Letter of Objection to the development at Former Tower Car Sales, Tower Close, East Grinstead, West Sussex (now known as Whittaker House, 1 Leppard Walk) and retrospective application DM/26/1446

This application is ostensibly the same as the original application DM/26/0432; due to this I have included my original complaint letter from that application as Appendix A to this letter - I would like my original letter of complaint for DM/20/0432 to be considered in its entirety regarding this application.

The promotional material (same images as submitted plans); the current front of the building;

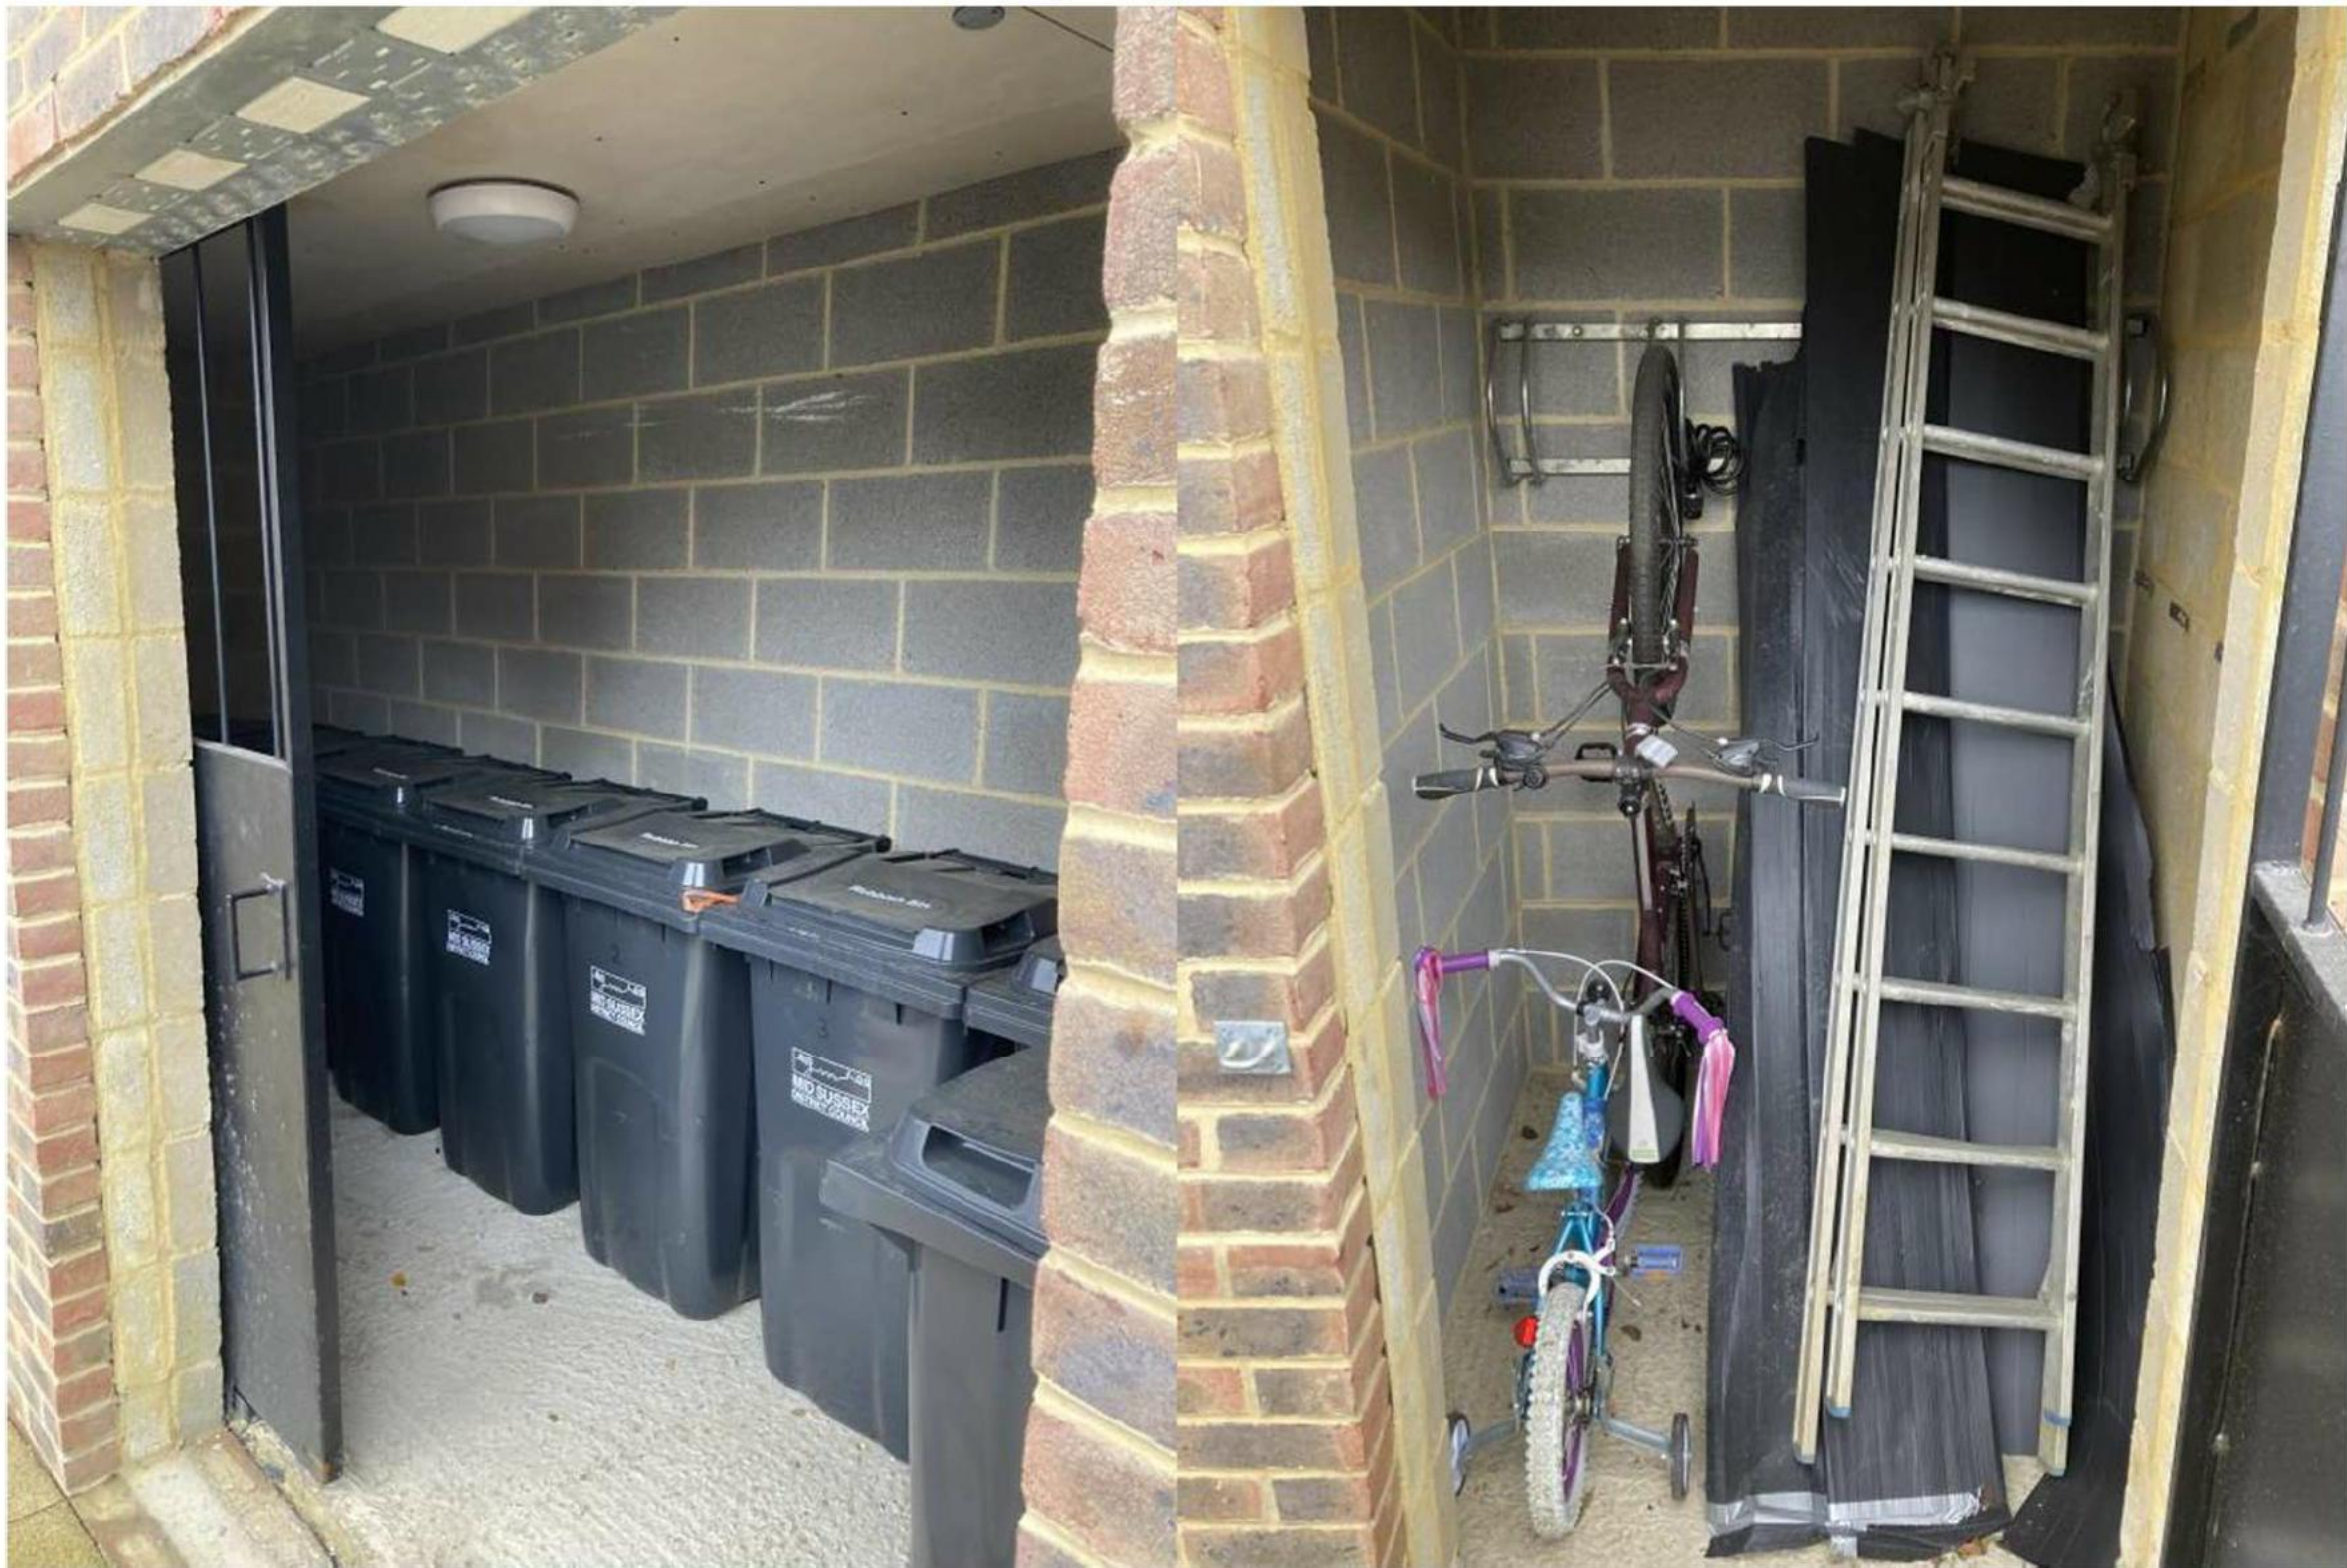
The entrance is now our 'dedicated bin and bike storage'. These are so unsuitable for the purpose as to be functionally useless. They remain unfinished, with unfinished brickwork (and bin storage) now forming part of the view for our neighbours. The bin storage area holds 8 bins, with the 9th squeezed in. Our recycling bins now live in the undercroft, as there is no 'dedicated bin storage'. The 'dedicated bike storage for 10 bikes' is honestly my favourite part of the development:

Dedicated bin storage; Dedicated secure storage for 10 bikes

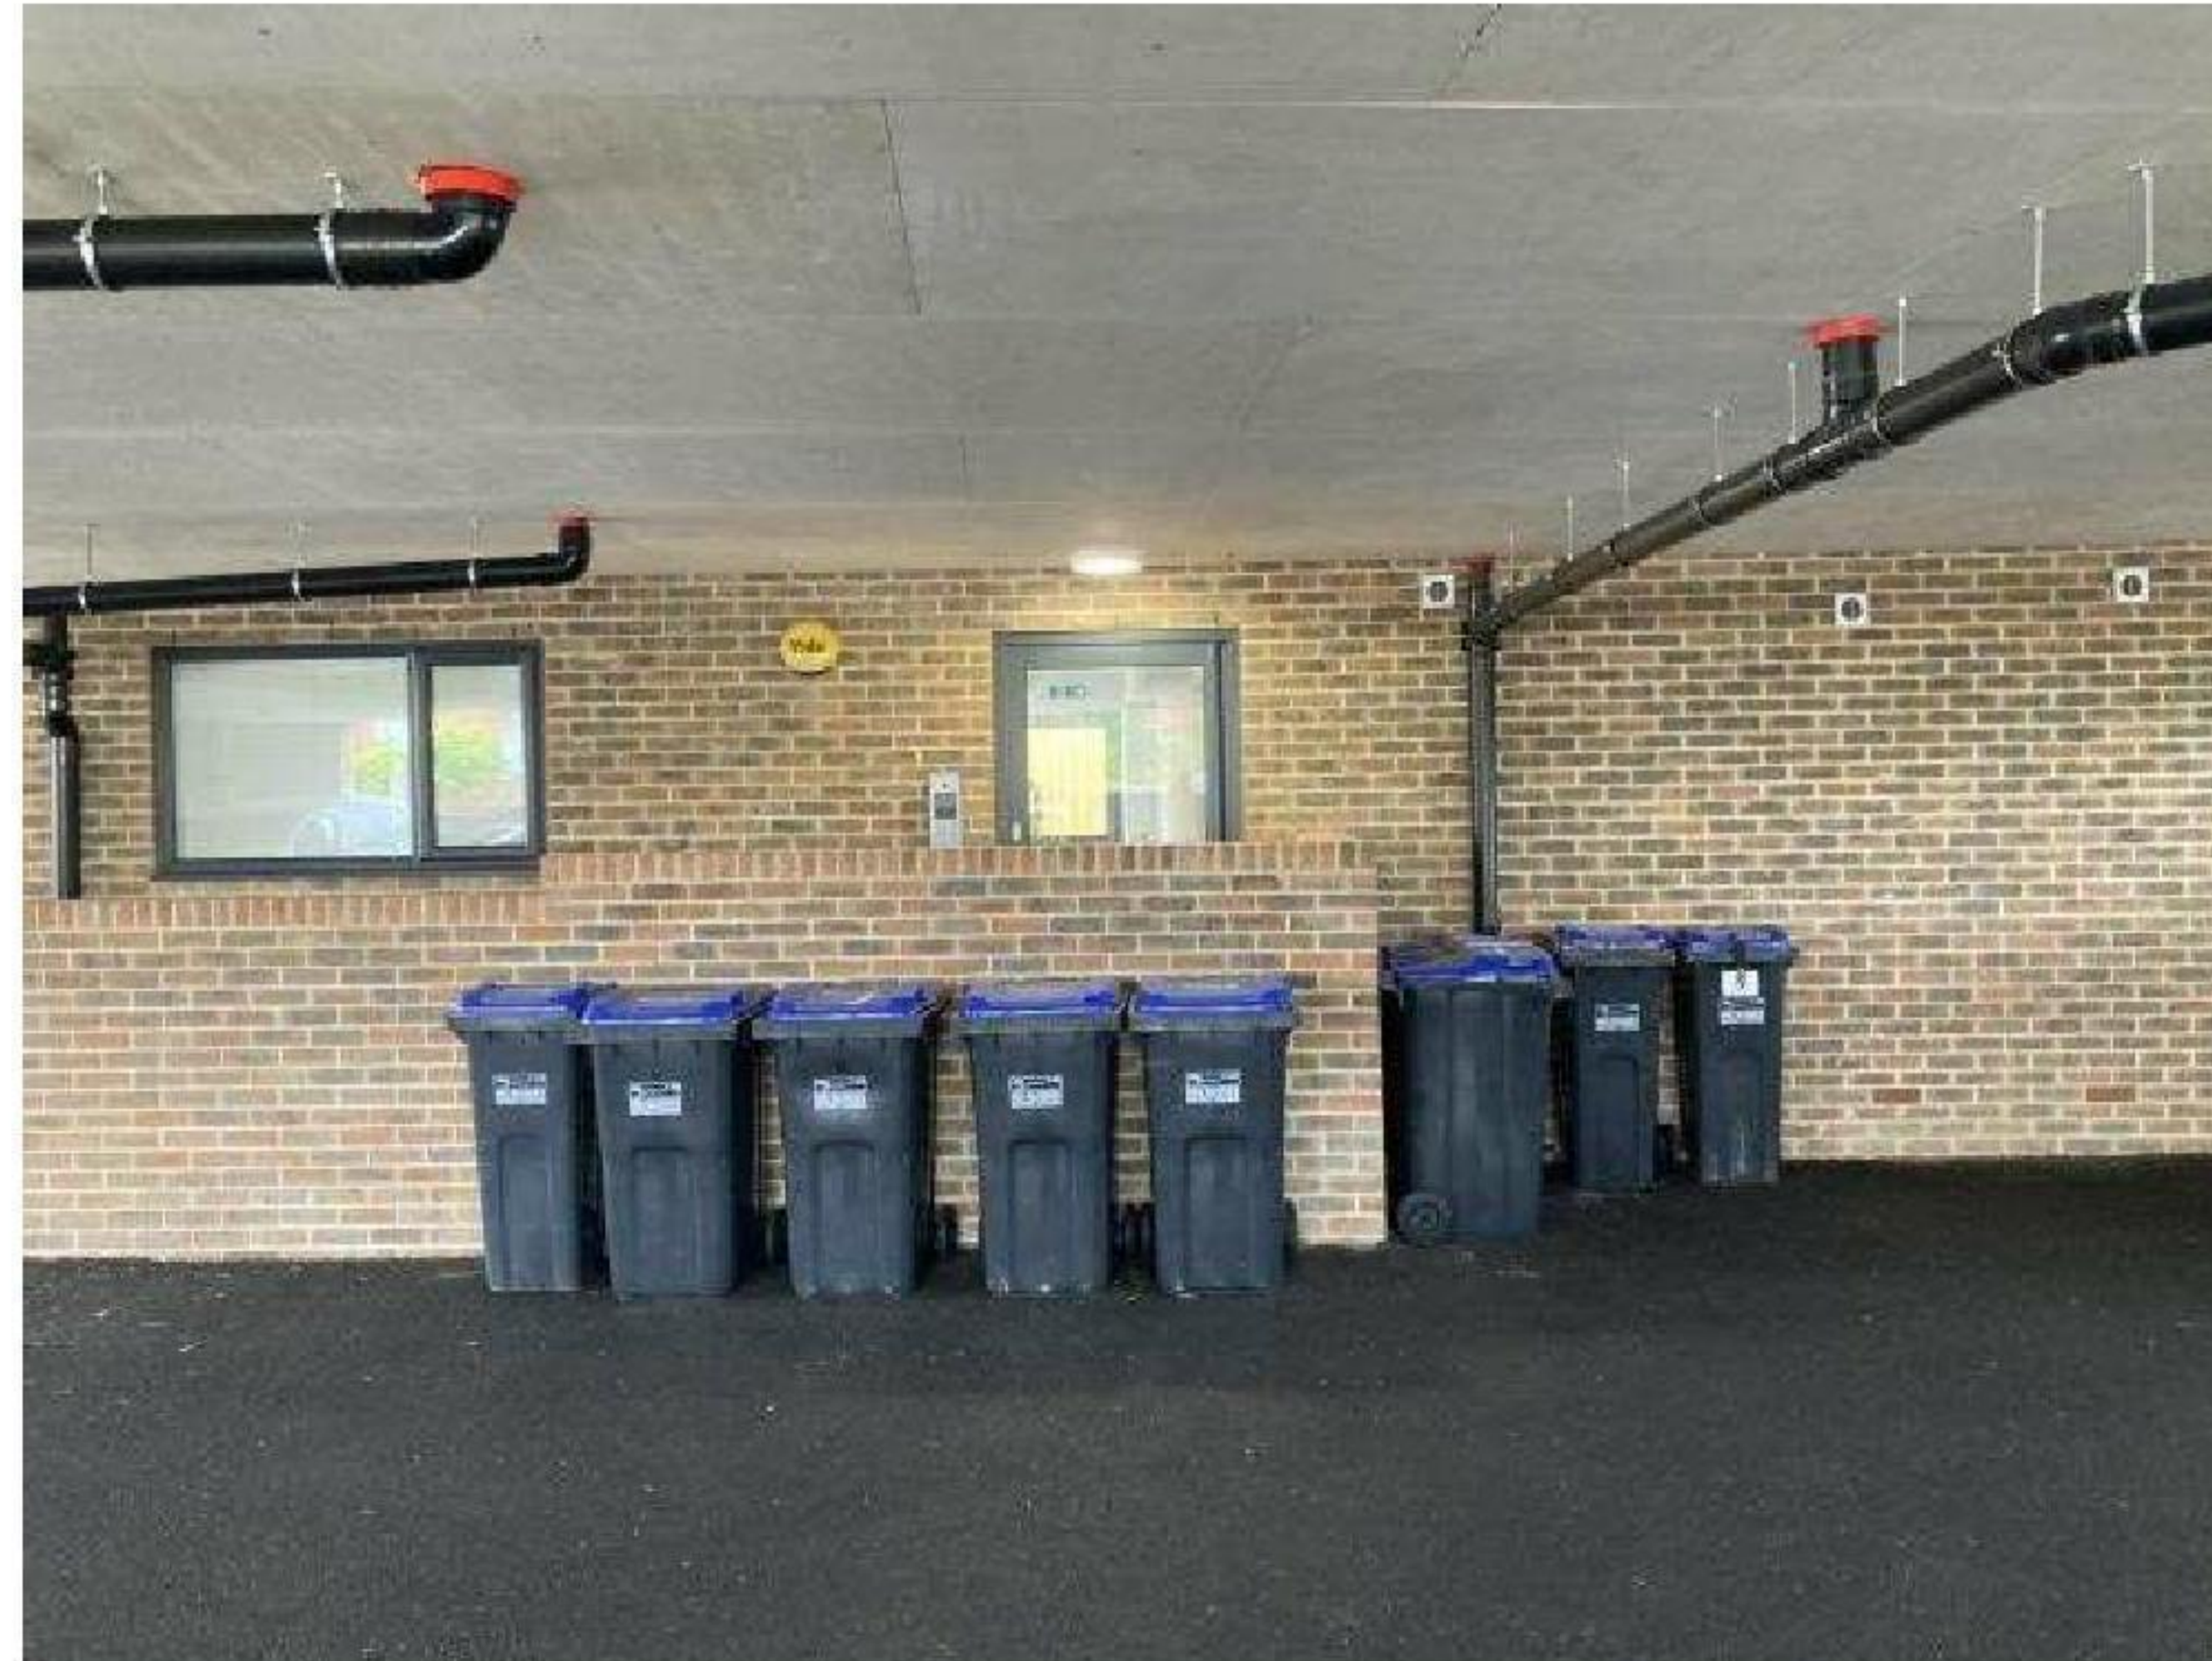
It would be funny if the property hadn't been marketed and sold as having dedicated secure bike storage, if said storage wasn't also mentioned when granting planning permission, and if several of the current freeholders hadn't purchased their property with this specific feature in mind.
